Our reference: SF17/45272; DOC19/29180-04
Contact: Ms Alex McGuirk; (02) 6333 3807

**BELL QUARRY REHABILITATION DA294/18
INTEGRATED DEVELOPMENT APPLICATION – RECOMMENDED REFUSAL**

Environmental Impact Statement (EIS) for the proposed Bell Quarry Rehabilitation (Lithgow DA294/18) - Comments

Figure 2. Principal Components Analysis of Selected Soil Types tested in the EIS. Points closer together are more similar in their soil components than points/sites further apart. Vectors indicate increasing values of individual contaminants in the direction of the lines.

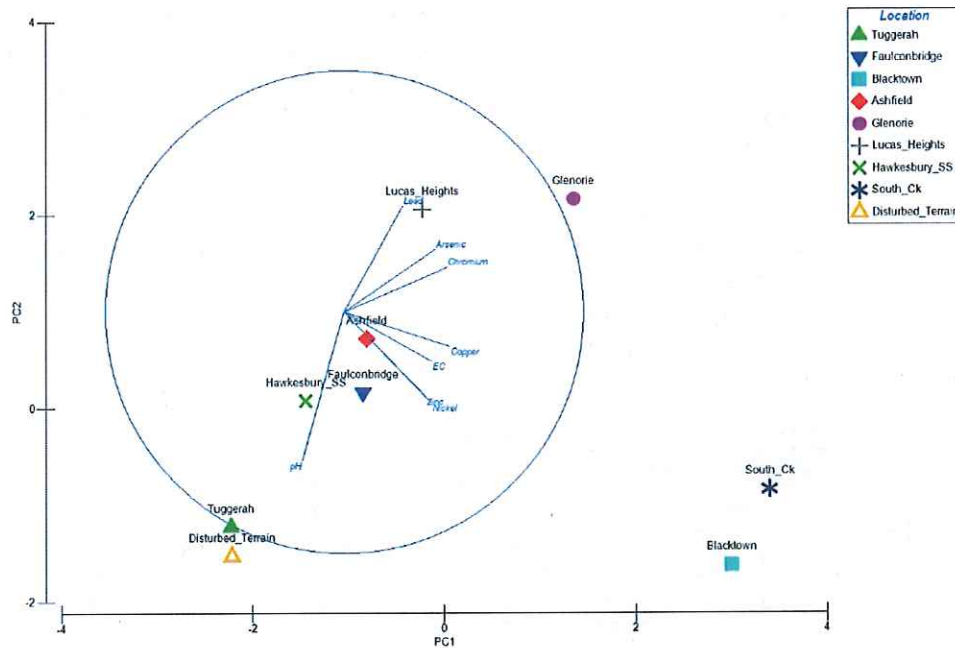
Whilst the EIS provides indicative soils that might be emplaced in the abandoned Bell Quarry pits, it does not appear to have made a similar assessment of the soils in the immediate area of Bells Quarry. This makes it very difficult to compare soil types proposed to be placed in the quarry pits and understand how they differ from soils that occur naturally in the vicinity of Bells Quarry.

The soil/rock sampling undertaken was stated to be limited in nature and was not considered to constitute detailed site investigation of each source site, or each soil/rock landscape/formation (ADE 2017). If the soil characteristics provided in the EIS are analysed using Principal Components Analysis, then the South Creek and Blacktown soils are quite different to the majority of other soil types tested, being relatively higher in terms of zinc, nickel and copper. It is possible that localised soils in the vicinity of Bell Quarry might be more similar to Hawkesbury sandstone, but seeing as the local geology is primarily Narrabeen Sandstones and/or Buralow Formation sandstone and shales, there are still likely to be differences. It is considered a deficiency of the EIS that local soils were not also analysed to provide a comparison to the soil types proposed for emplacement in the pits. Leachates from the tested soils are discussed further below (in the Water Quality Section).

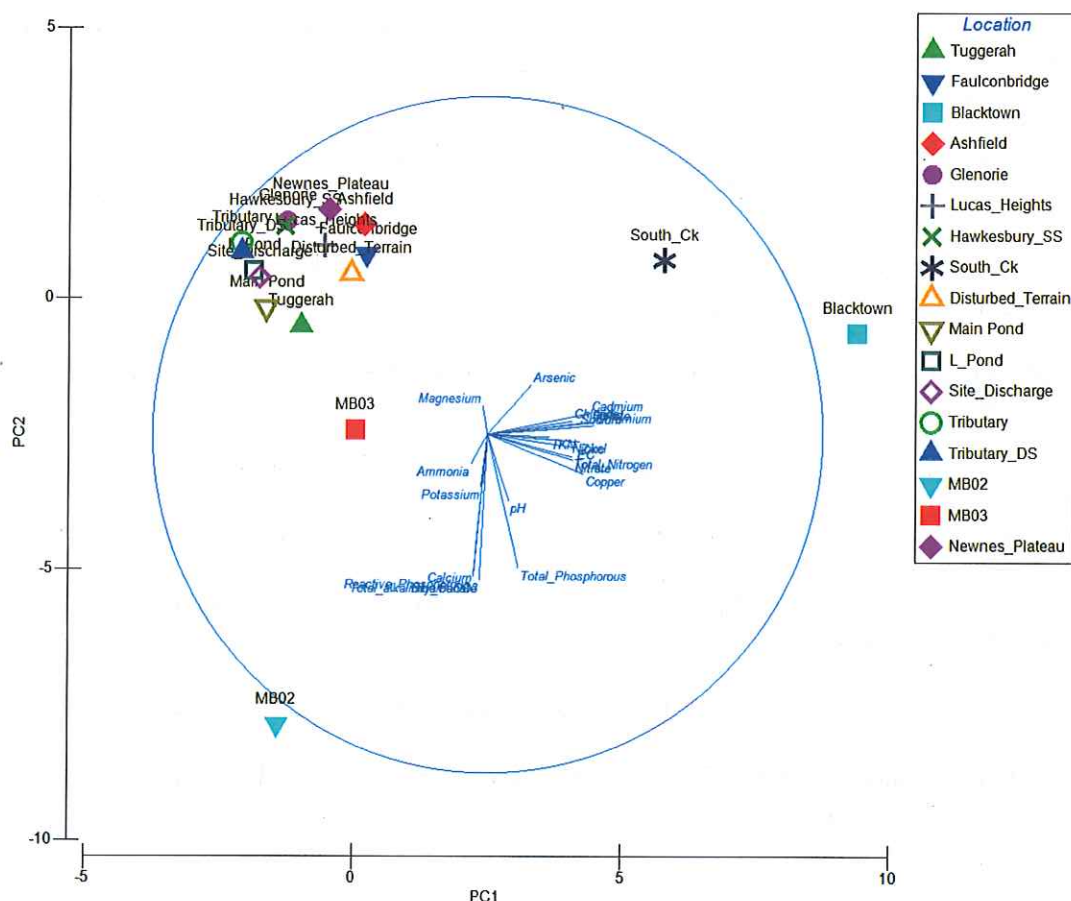
If the leachate characteristics provided in the EIS are analysed using Principal Components Analysis then the South Creek and Blacktown leachates are quite different to the majority of other soil leachates, quarry pit water samples and stream water samples from the Bell Quarry location (see Figure 9). The Blacktown soil leachate was relatively high in terms of zinc, nickel, copper and Total Nitrogen. The South Creek soil leachate was relatively high in terms of Sodium, Chloride, Arsenic and EC. Groundwater (locations MB02 & MB03) was relatively higher in total alkalinity, total phosphorus, reactive phosphorus and pH.

What GHD (2018a) fail to discuss in this context is that:

- the zinc measurement for W1 (0.0056 mg/L) was in between ANZECC levels to protect 95% and 99% of species
- the zinc measurement for W3 (0.019 mg/L) was influenced by the Clarence Colliery discharge¹²
- the zinc measurements for soil leachates ranged from a minimum of 0.03 mg/L (Tuggerah Soil Type) to a maximum of 0.484 mg/L (Blacktown Soil Type)¹³
- Table 5-9 identifies a range of other leachate results with exceedances of the ANZECC (2000) GV.s.
- Only one leachate sample has been measured for each soil type (ie no replication)
- The soils tested may not be representative of the 'worst' soils likely to be emplaced in the quarry pits.

If the project is considered for approval it is recommended that an impervious membrane (liner) is installed in the quarry pits to prevent leachate moving into groundwater in the area and then into the GBMWHA.
